RENOVATIONS TO THE  
**WALLEY SCHOOL**  
260 HIGH STREET, BRISTOL, RI 02809

SHEET TITLE  
**Layout and  
Materials  
Plan**

SHEET  
**C2.0**

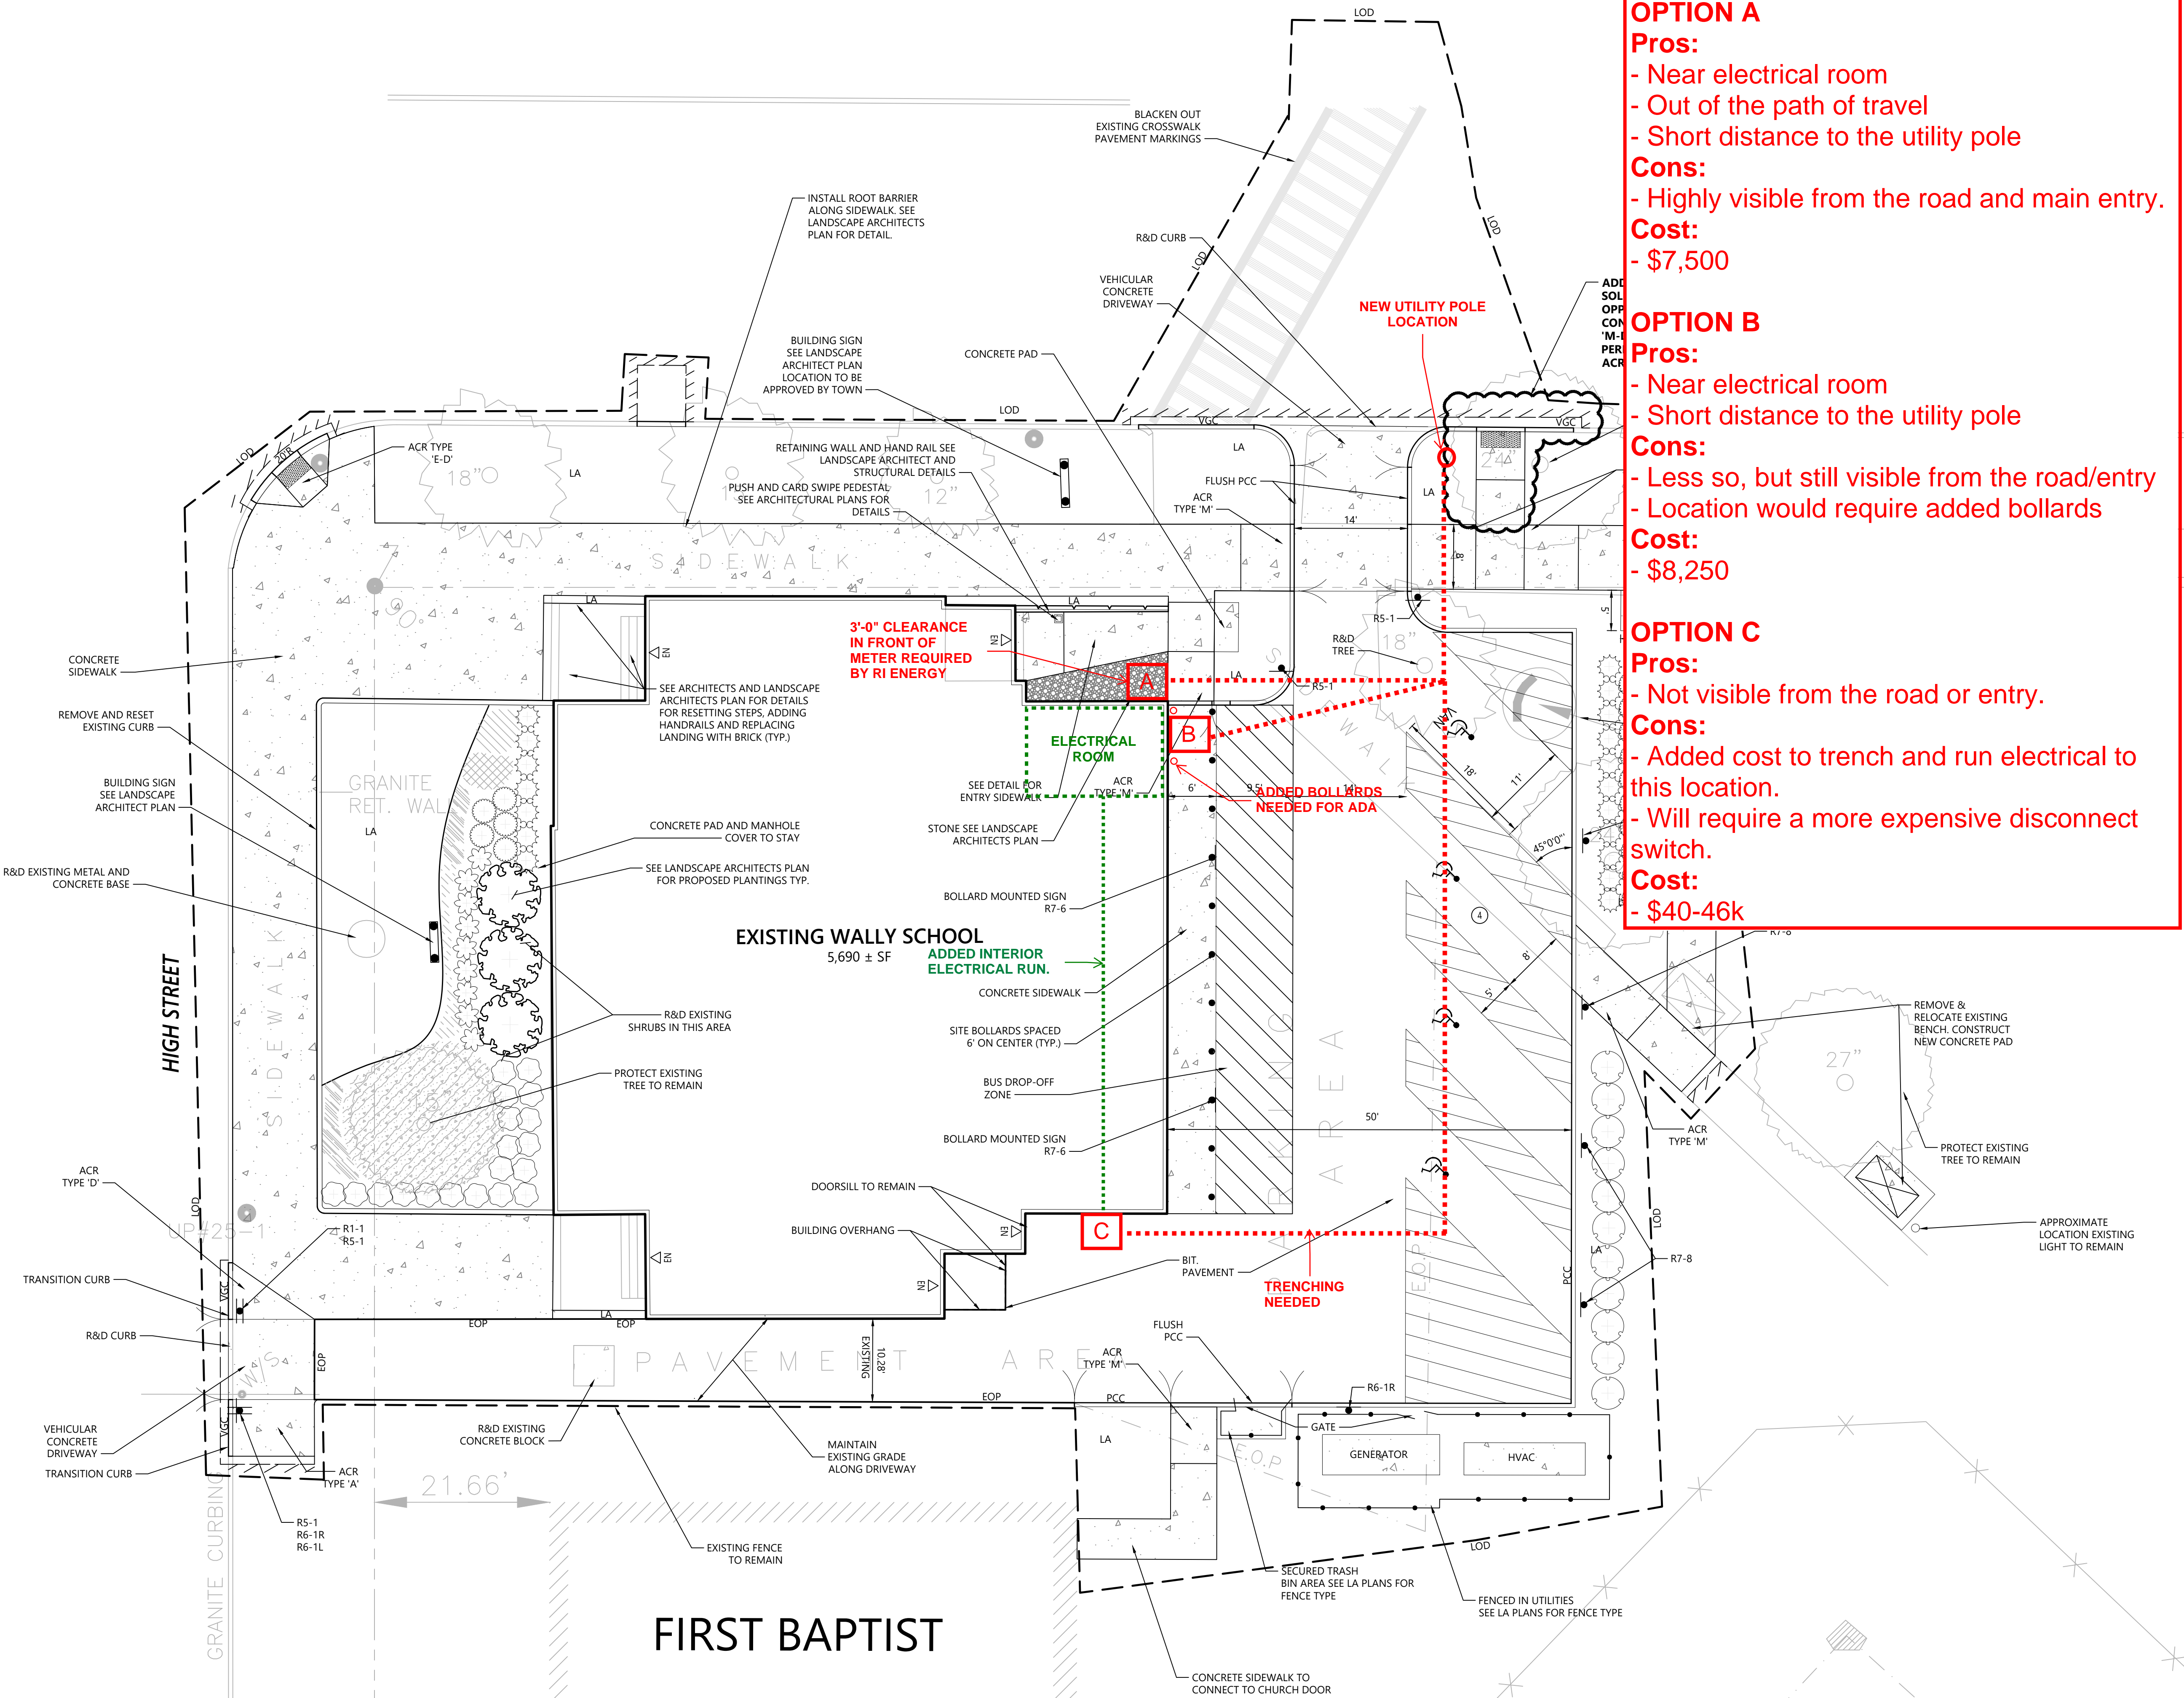
- OPTION A**  
**Pros:**  
- Near electrical room  
- Out of the path of travel  
- Short distance to the utility pole  
**Cons:**  
- Highly visible from the road and main entry.  
**Cost:**  
- \$7,500
- OPTION B**  
**Pros:**  
- Near electrical room  
- Short distance to the utility pole  
**Cons:**  
- Less so, but still visible from the road/entry  
- Location would require added bollards  
**Cost:**  
- \$8,250
- OPTION C**  
**Pros:**  
- Not visible from the road or entry.  
**Cons:**  
- Added cost to trench and run electrical to this location.  
- Will require a more expensive disconnect switch.  
**Cost:**  
- \$40-46k

SHEET  
**A2.1**

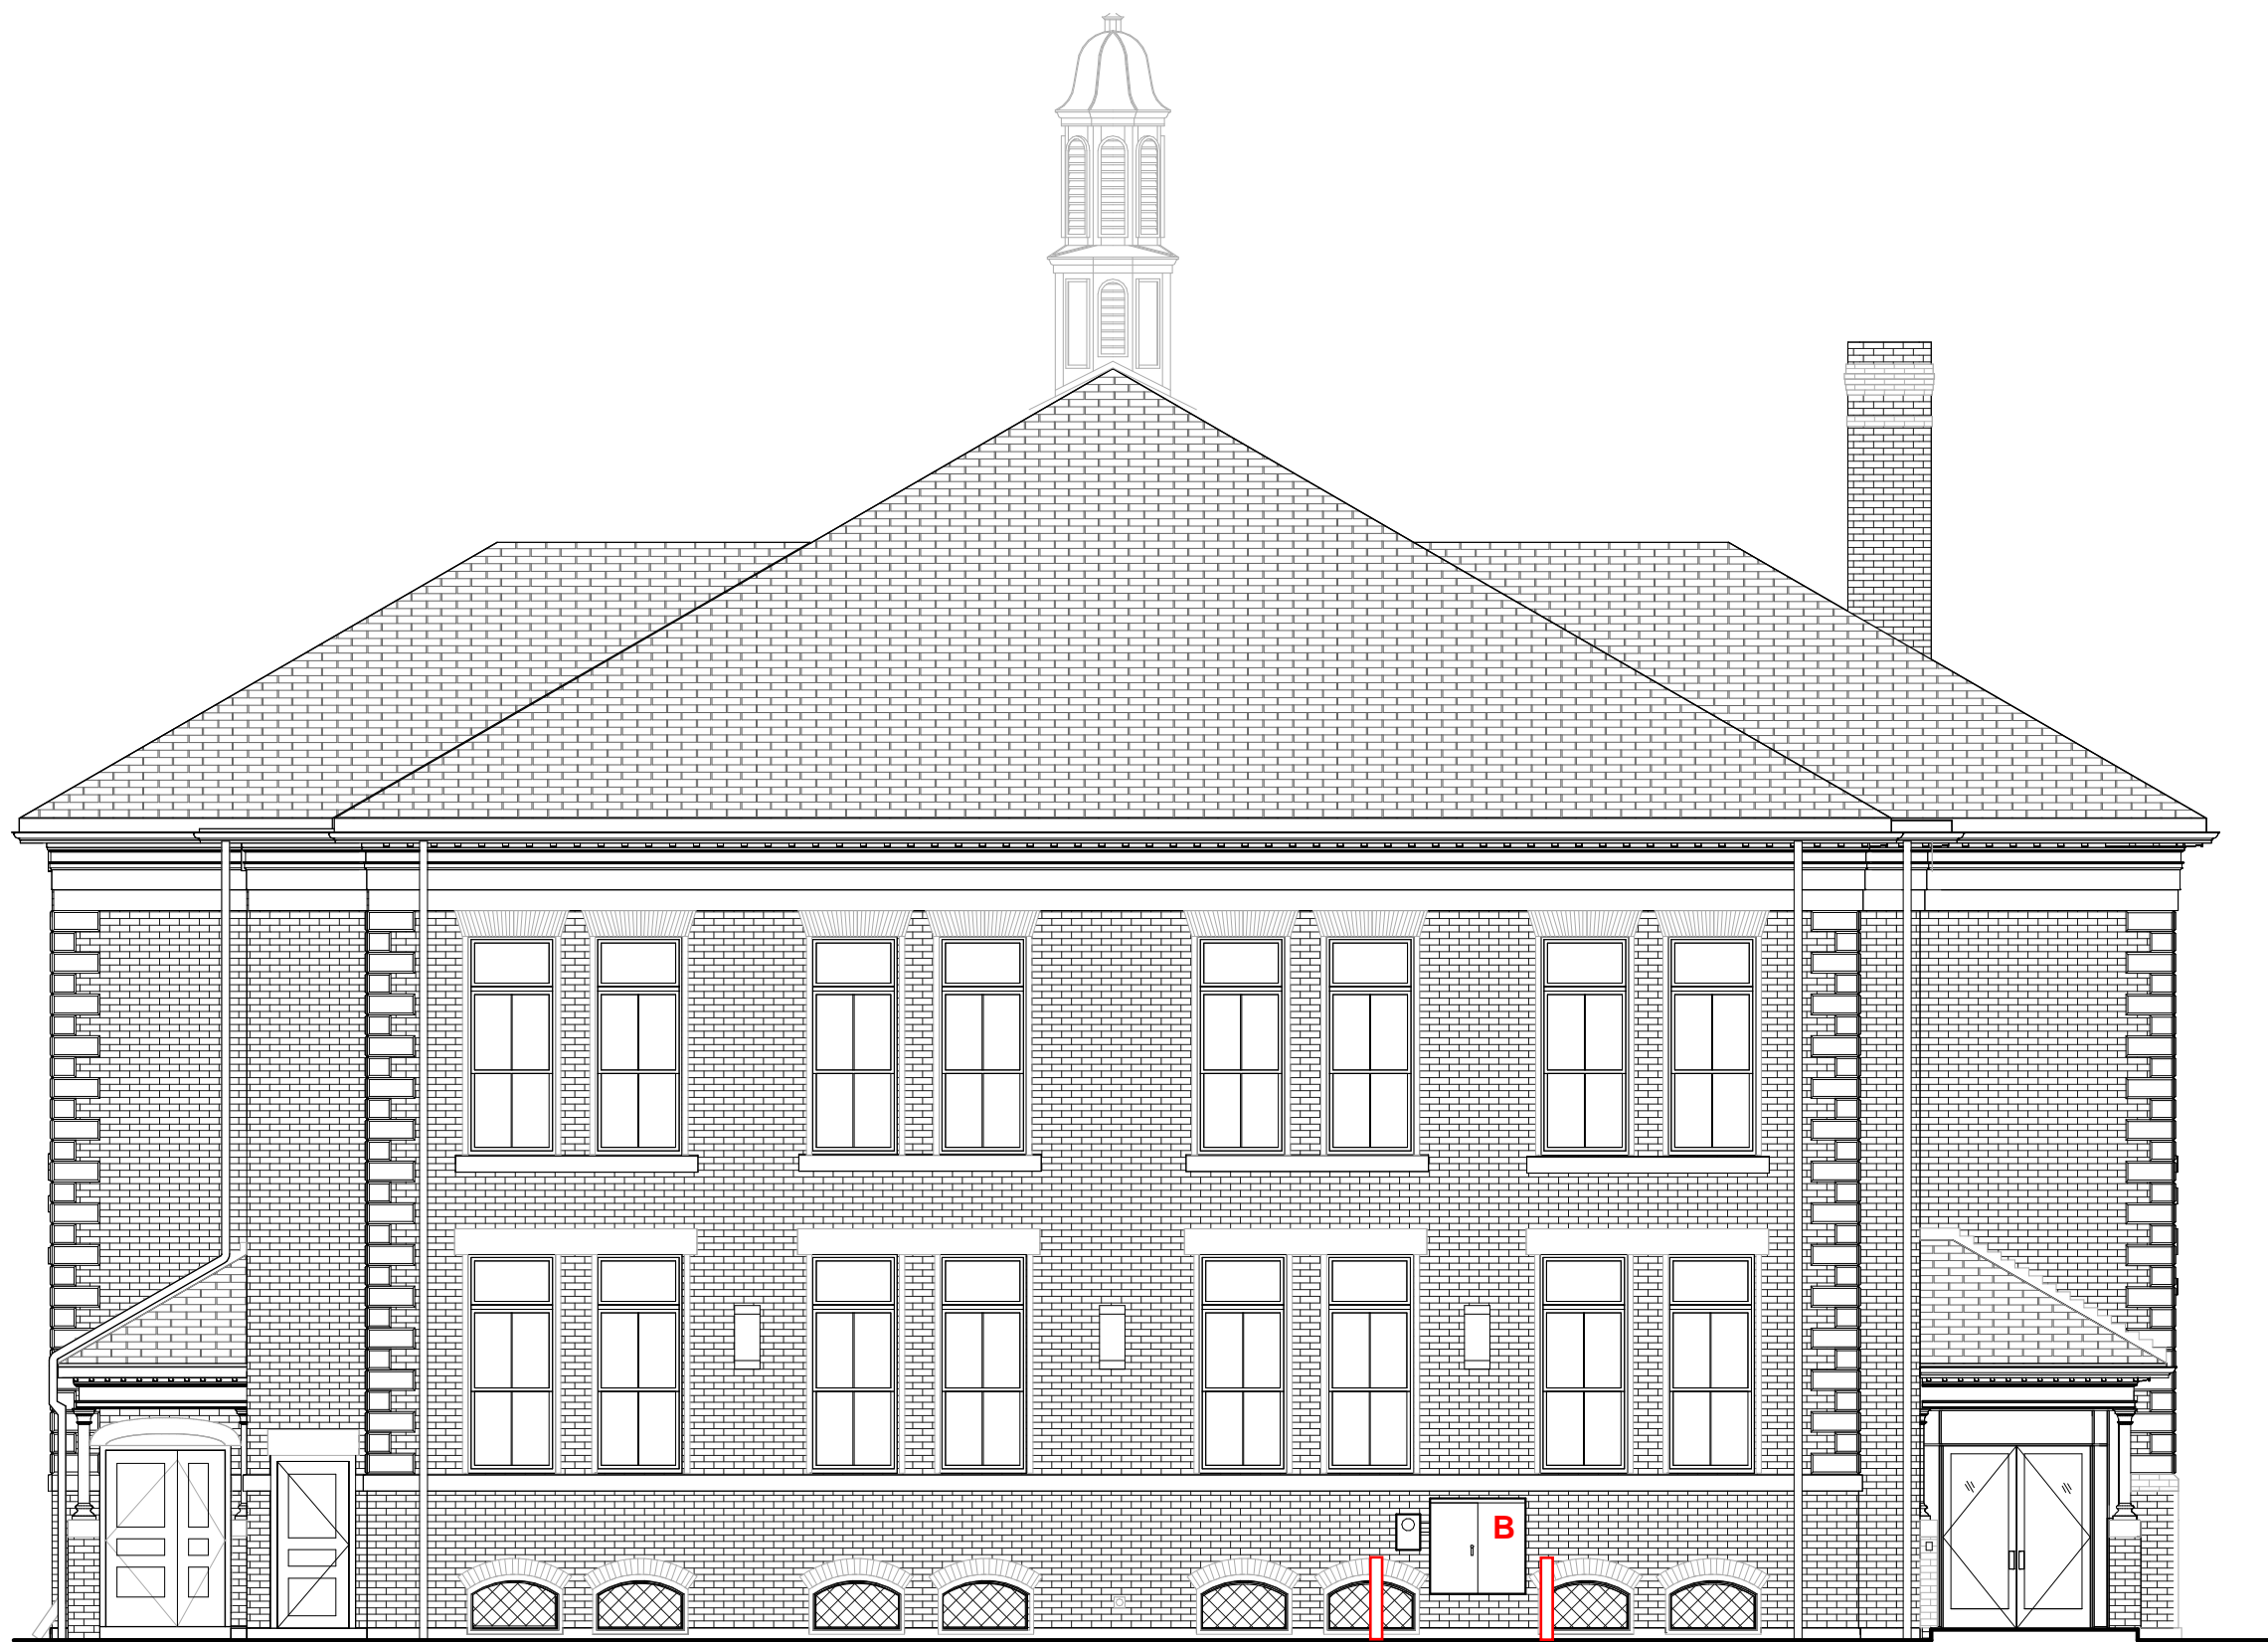
**METER WILL BE  
INSTALLED TO THE  
SIDE**
